AGENDA
PLANNING AND ZONING COMMISSION MEETING
CITY OF CREVE COEUR, MISSOURI
WEDNESDAY, JUNE 3, 2020

1. PUBLIC HEARING. Application #20-002 & #20-010: Boundary Adjustment, Site Development Plan and Conditional Use Permit for QuikTrip Gas Station with Convenience Store at 11004, 11026, and 11032 Olive Boulevard and 825 and 827 Graeser Road, and the Redevelopment of the Adjacent Retail Center at 11032 and 11056 Olive Boulevard

**APPLICATION TO PLANNING AND ZONING COMMISSION
#20-002 & #20-010: BOUNDARY ADJUSTMENT, SITE DEVELOPMENT
PLAN AND CONDITIONAL USE PERMIT FOR QUIKTRIP GAS STATION
WITH CONVENIENCE STORE AT 11004, 11026, AND 11032 OLIVE
BOULEVARD AND 825 AND 827 GRAESER ROAD, AND THE
REDEVELOPMENT OF THE ADJACENT RETAIL CENTER
AT 11032 AND 11056 OLIVE BOULEVARD**

REPORT PREPARED BY: Whitney Kelly, AICP, City Planner
DATE: 5/26/2020
ATTACHMENTS: Applicant's Revised Materials received May 11, 2020
MoDOT Comments
City's Traffic Engineers, GBA, Response Letter
CBB response to comments dated May 26, 2020 and May 28, 2020
Letter from Graeser Neighbors received May 20, 2020
Comments received by May 28, 2020

Figure 7: Close-up of the North Elevation

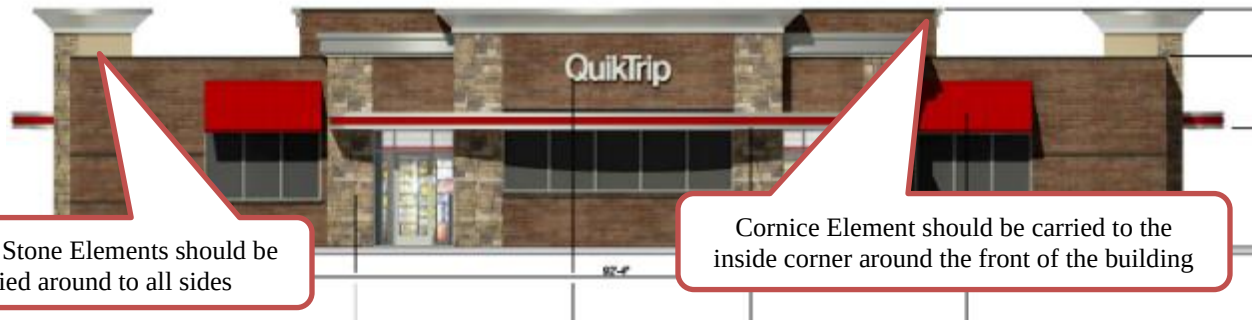
- *Building elements, such as parapet wall, penthouses or screen walls should be treated as an integral part of the architecture, and that material and color changes should occur at a change of plane.* The mechanical screening and parapet walls are well-integrated on the C-store that utilized the same brick material as the building. However, the stacked stone materials are not carried all the way around on the east and west tower elevations, and the metal coping around the mechanical screening should be carried to the inside edge around the front of the store.

Figure 9: Close-up of the rear elevation of the retail center

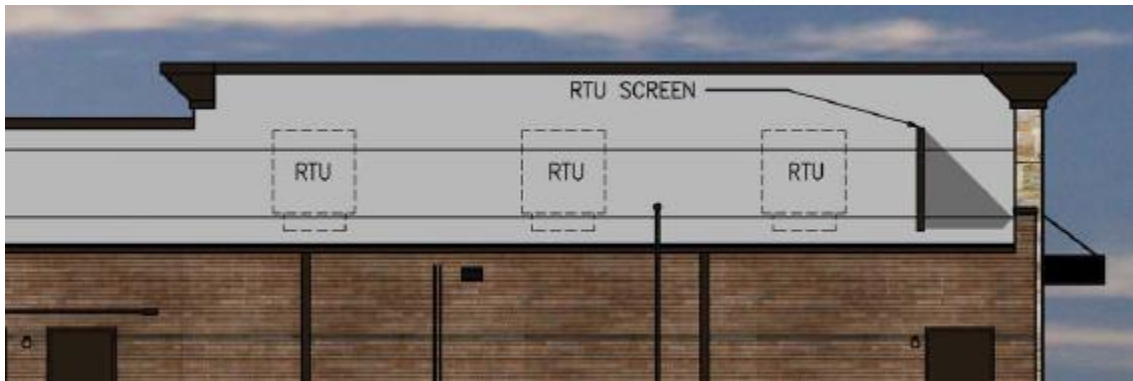
Staff is unclear if the rear of the building provides for roof-top screening, with the two lines not identified, and the mechanical equipment in dashed lines that generally indicate that it is located behind an element.

Figure 10: Close-up of the site plan showing the main entrance.

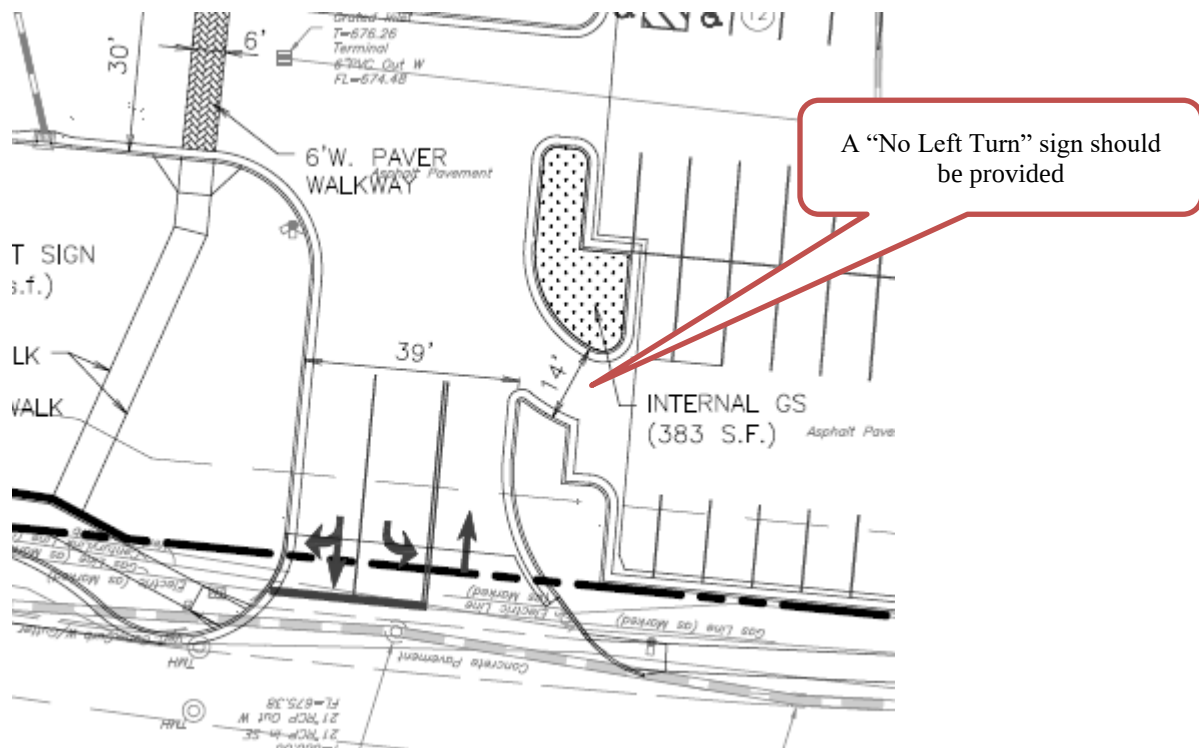
- Access to all service stations should be limited to 2 curb cuts. If at a corner, there should be no more than 1 curb cut per street. Raised planters should be used at various locations to ensure customer safety. The retail center shows the maintenance of the existing entrance that will serve both the gas station and the retail center as a full access. The gas station property is limited to the right in and right out only on Olive, and one access along Graeser Road. MoDOT has concurred with this layout due to the island within Olive Boulevard and the proximity to the intersection. Staff does recommend that a “No Left Turn” will be needed for the parking lot exit. Additional landscaped areas have been provided that are properly curbed within the retail center parking lot, as well as curbed landscape areas for the walkway in front of the C-store. A retaining wall and landscaping are provided between the parking and the new sidewalk along Graeser Road, to comply with these recommendations.

Figure 11: Close-up of the side elevation of the canopy structure

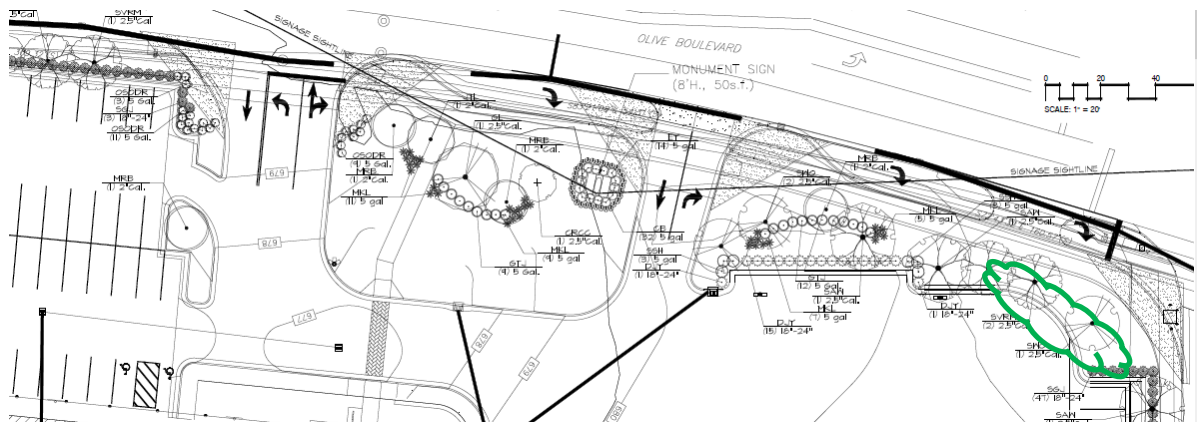
- Separate structures, such as a canopy, car wash, or cashier's booth, on the site should be avoided. When requested and approved separate structures are to have consistent architectural detail and design elements that provide a cohesive project appearance. The Canopy structure does provide similar details as the C-Store and retail building with the use of stacked stone. However, Staff recommends that the stone, or a combination of the stone and

Figure 15: Close-up of the rear of the development on the area formerly 825 & 827 Olive Boulevard

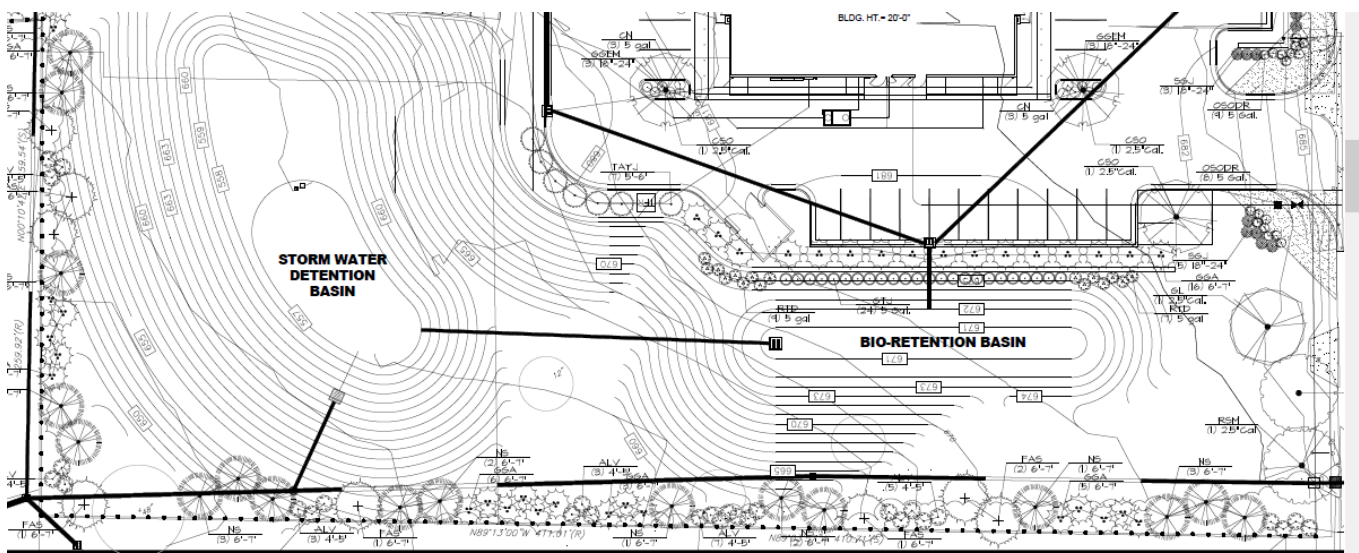
The rear landscaping provides significant evergreens to provide year-round screening along the property lines in addition to the 8-foot tall wood shadowbox fence. Additional landscaping is

proposed along the base and on top of the retaining wall along the back of the building and parking area, in compliance with the City's Design Guidelines that recommend minimizing the height and length of the retaining walls and screen with appropriate landscaping. Additionally, retaining walls in excess of 4-feet in height should be terraced with planting area terrace separation between levels, and materials utilized for the retaining wall should match the primary building materials. With respect to the fence, the Commission should determine if it should be placed at the property line as shown, or interior to the site with the evergreens placed on both sides, so that the residents benefit from the landscaping.

Figure 16: Close-up of the site plan showing sidewalks in front of the store.

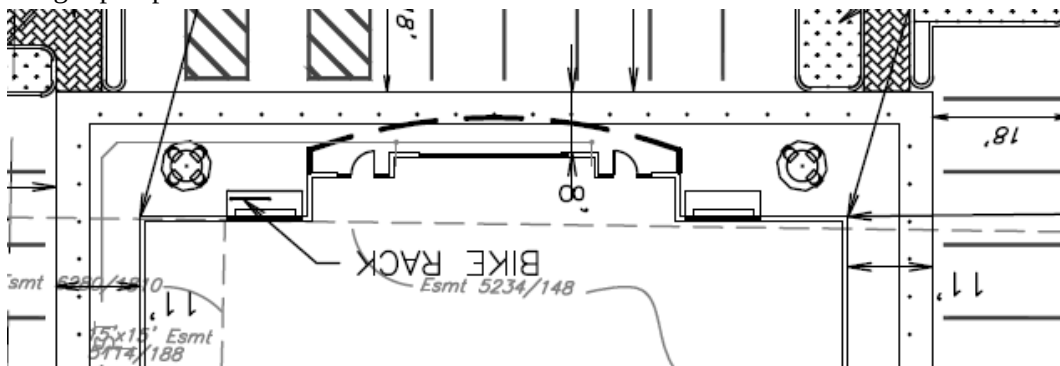
- *The Design Guidelines recommend that sidewalks in front of retail businesses in a commercial district should be a minimum of 10 feet and include pedestrian amenities such as planters and benches. Outdoor sales, dining or storage should not impair pedestrian movement, and should maintain a minimum 4-foot clearance path along the sidewalk. Section 405.730(A)(2) Sidewalks of the Zoning Ordinance requires a minimum width of internal sidewalks in non-residential developments to be at least six feet and eight if used as a curb stop discussed further below. The Applicant is showing 8-feet along the front of the central tower element, and eleven feet along the east and west sides of the building. Table seating and a bike rack are provided along the front elevation, per the image below. However, the drawings show low bollards within this area, therefore staff recommends a condition of approval that at least six feet of clear access be maintained between the bollards and the building entrances, to comply with the requirements of the Zoning Ordinance and the Design Guidelines. The front elevations are also broken up with pedestrian elements and landscaping including access for those walking to the front doors from the gas pumps.*

Figure 17: Close-up of the Site Plan showing new detached sidewalks along Graeser Road on right and Olive Boulevard on left

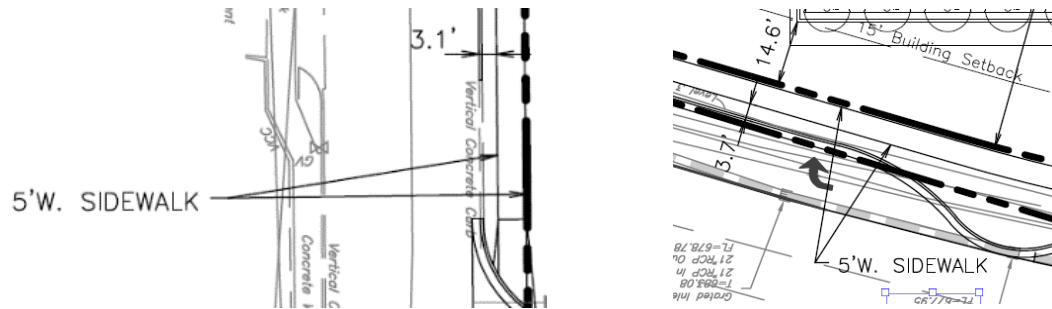
- The Applicant is showing that all pedestrian crosswalks will utilize a stamped textured concrete in furtherance of the Design Guidelines that recommends at intersections, crosswalks, and main building entries, a change in sidewalk color, texture, or material should emphasize the location. Paint Striping to accentuate these areas is strongly discouraged. (p. 5). And is required in Section 405.730(A)(1)(c) Sidewalks of the Zoning Ordinance.
- The City's Pedestrian Plan indicates that Olive Boulevard as a primary street should have a separated sidewalk, as well as provide for a separated sidewalk along Graeser that are 5 feet in width. The Applicants are providing for new separated sidewalks along both Olive and Graeser Roads. The Graeser Road sidewalk is within the existing right-of-way, and therefore will not require an easement to the City.

Figure 18: Close-up of the Site Plan showing buffer area

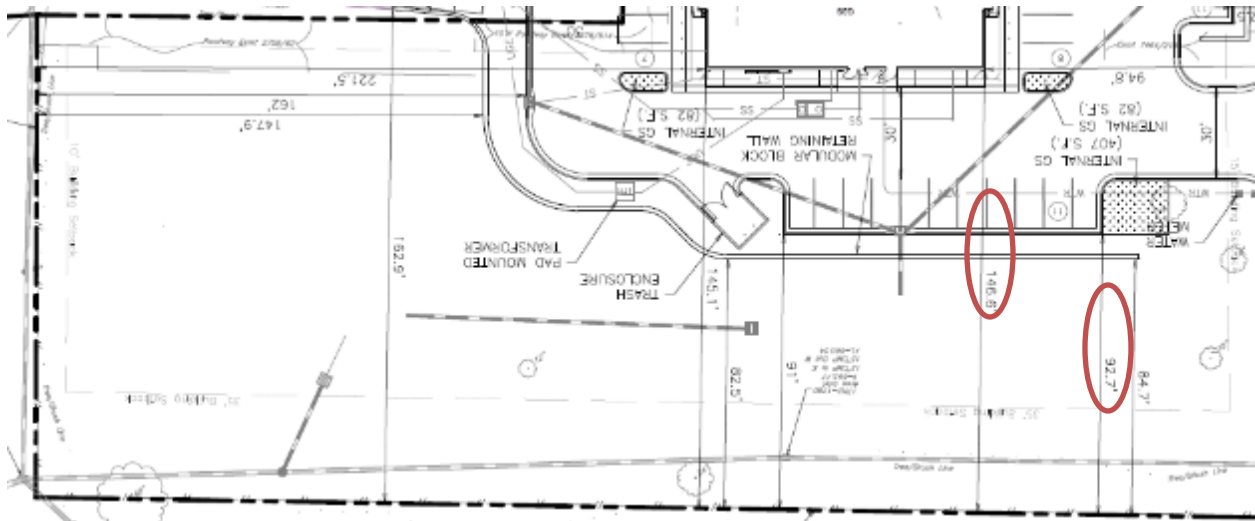
and provided with other screening devices as deemed appropriate by the Planning and Zoning Commission. As discussed above, the proposal will consolidate the non-conforming six parcels into one 2.54 acre parcel (+0.06 acres dedicated for right-of-way) for the gas station lot; and the remaining portion of 11032, and 11056 Olive Boulevard into one 1.82 acre parcel (+0.01 acres dedicated for right-of-way) for the existing retail building, with significant buffering that exceeds the required minimum buffer of 25 feet, where almost 93 feet of landscaping from the rear parking to the nearest residential property line.

Figure 20: Close-up of the "Demo" Plan and the Site Plan of the two parking spaces that will have to be removed and the existing green area to remain.

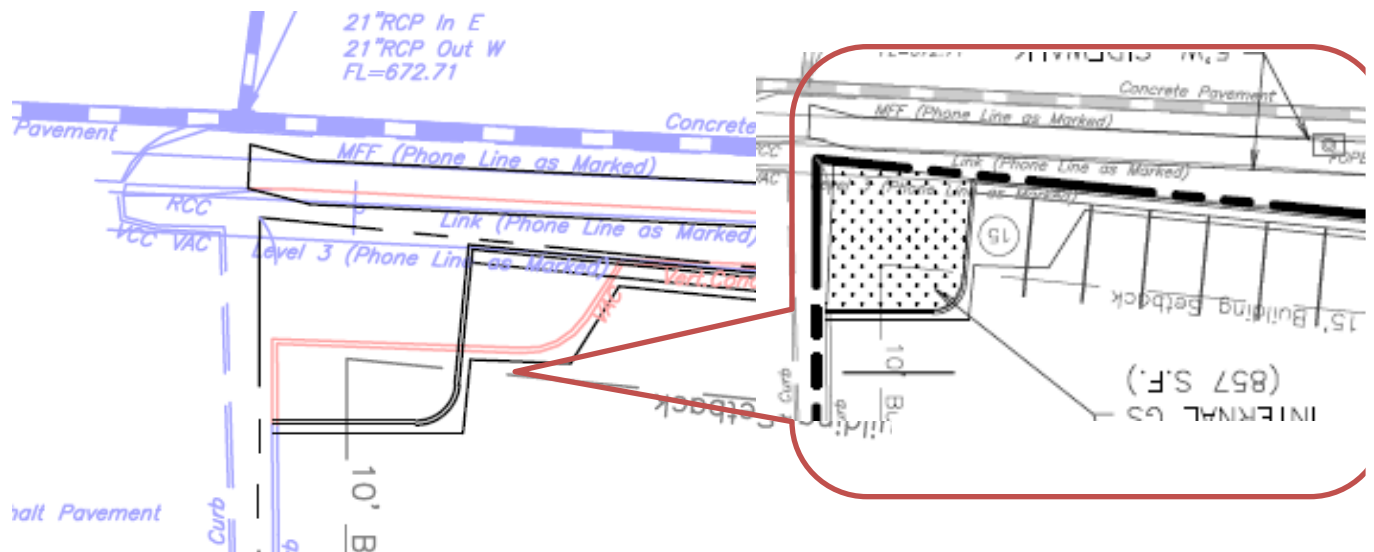
The site data table on the drawings is showing incorrect information. Below are the corrected site data table for each of the properties. The table also includes the reduction of the retail center parking to be 84 spaces. The existing parking along Olive Boulevard is pre-existing non-conforming, in that they are placed at the property line, where the current regulations require a minimum of 10 feet of landscaping and/or pedestrian facilities, per Section 405.240(B)(2) of the Zoning Ordinance. The site development plans showed an addition of two parking spaces in line with the existing parking at the northwest corner of the site, where there is currently landscaping. Therefore, the parking spaces on the drawings will have to be removed as it would be increasing the number of parking within the setback.

Figure 21: Close-Up of the Elevations Showing the Trash Enclosure.

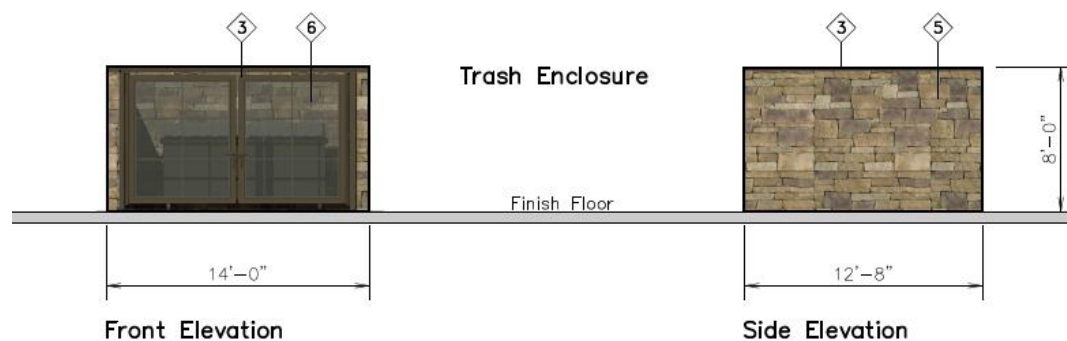
As discussed above, the proposal includes an 8-foot shadow-box wood fence and significant evergreen landscaping at the property line as well as upright evergreen plantings behind the building to screen the retaining wall, and building. The Applicants have indicated that the proposed wood fence is sufficient in consideration of the significant landscaping, as well as over 92 feet between the closest residential property line to the rear parking, and 146.5 feet to the rear of the building, and that a masonry wall is not necessary. Staff is generally in agreement with this, as in other areas where a solid wall was required, these sites were much more open and visible, with not as much landscaping, and the developments were closer to the residential areas. As discussed above, the Commission should discuss with the Applicant whether the fence should be placed at the property line or behind the proposed landscaping, so that the residents get the benefit of the evergreen plantings, and whether or not a masonry wall is needed. The trash enclosure material is a stacked pre-cast stone material that is consistent with the building materials, in compliance with Section 405.470 (A) (13)(g), and located behind the building out of view from Olive Boulevard in compliance with the Design Guidelines that the location of such services should be sited with limited visibility to pedestrians and/or adjacent properties (P.19). However, the final drawings for a permit will require a concrete pad to be provided within and adjacent to the trash enclosure.

Figure 22: Close-up of the Photometric Plan showing lighting levels underneath the Canopy Structure with the highest levels circled in red.

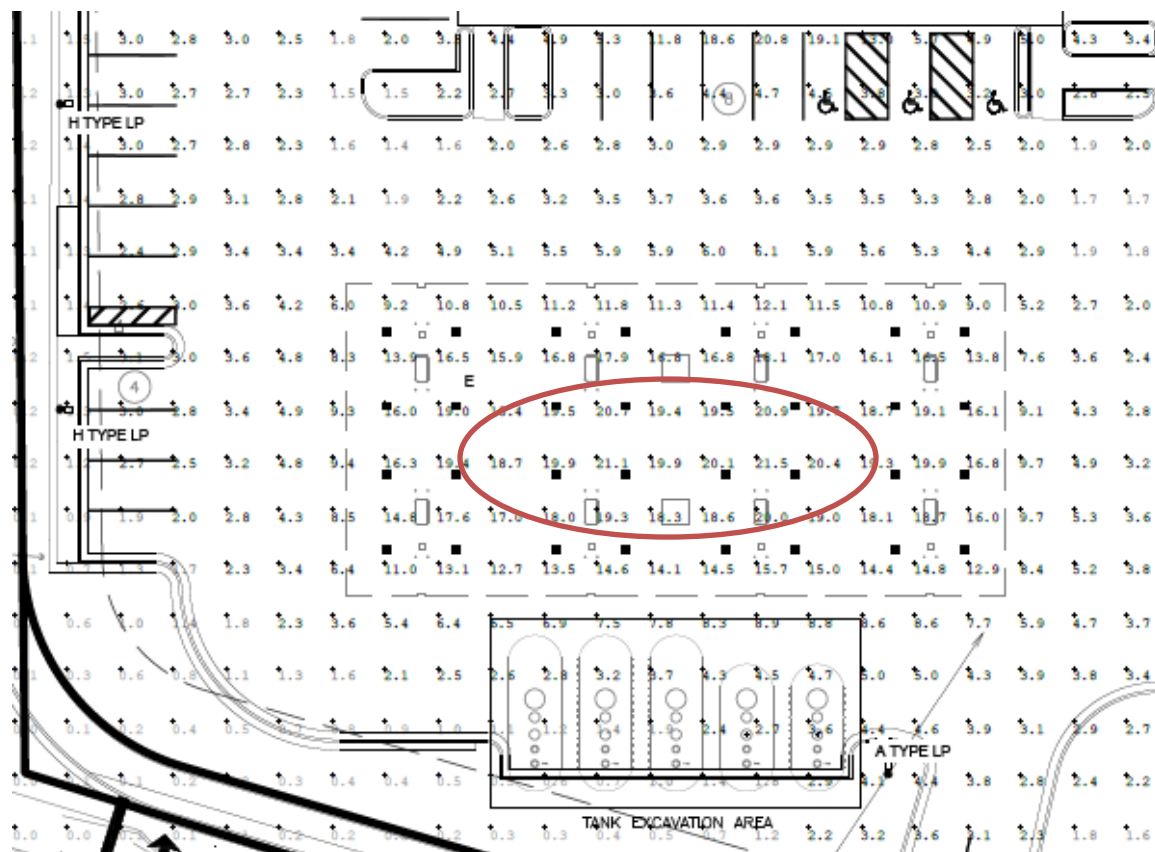
The photometric plan is showing the lighting between the hours of 10:00 P.M. and 6:00 A.M. to comply with the prior requirements. The Photometric plan is showing levels at a maximum of 21.5 underneath the canopy structure, and now light directed outward or onto adjacent property The Applicant has indicated that it will remain at this level during operational hours.

Figure 24: Close-up of the rendering of the monument sign

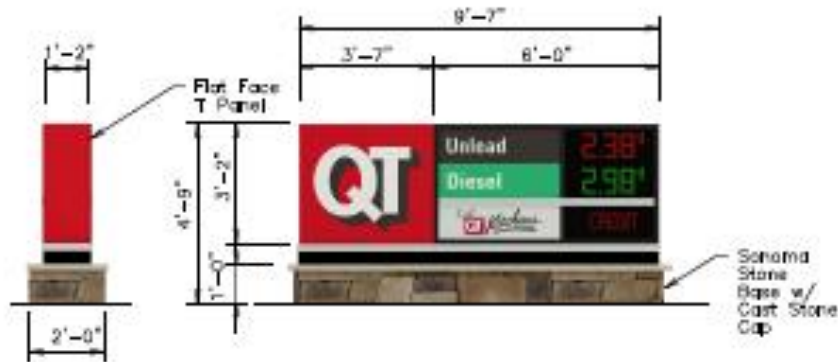
Further, Section 405.950(I) Gasoline Price Signs, provides for one (1) gasoline price sign allowed on the property. This sign must be freestanding and permanently anchored with a masonry base at least one (1) foot in height. Such a sign shall not exceed thirty (30) square feet in sign area per face and shall not exceed six (6) feet in height from top of sign to top of grade. Section 405.930(D)(13) provides that these signs are only to be manually changeable signs, where electronic changeable signs are prohibited. The renderings appear that the price is electronically changeable.

Figure 25: Close-up of the Boundary Adjustment Plat

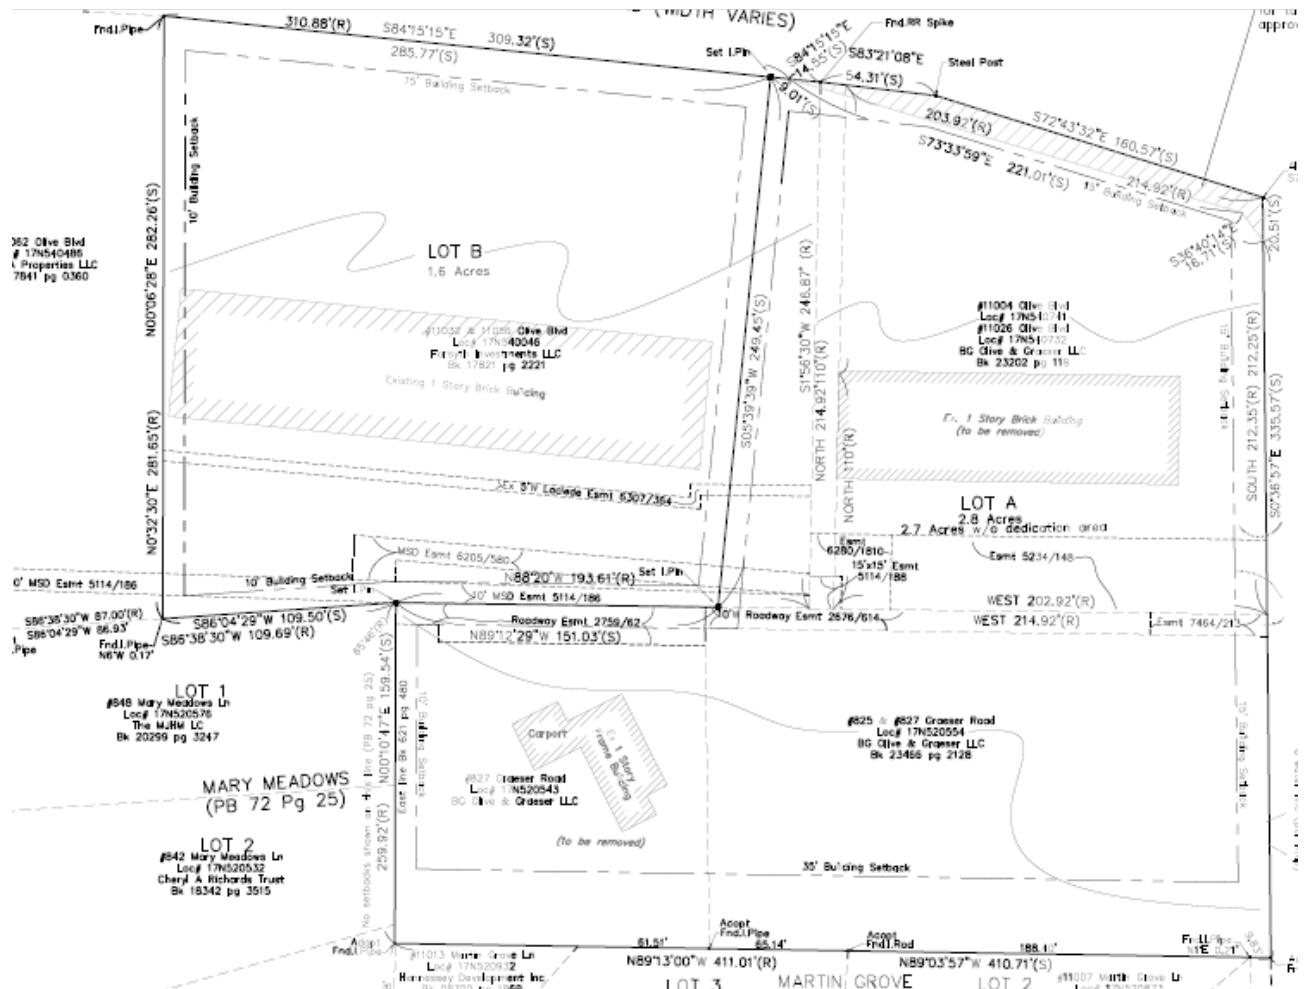
Adjustment Plat, the Site Development Plans and landscape plan is needed with the correct information, including site data tables.
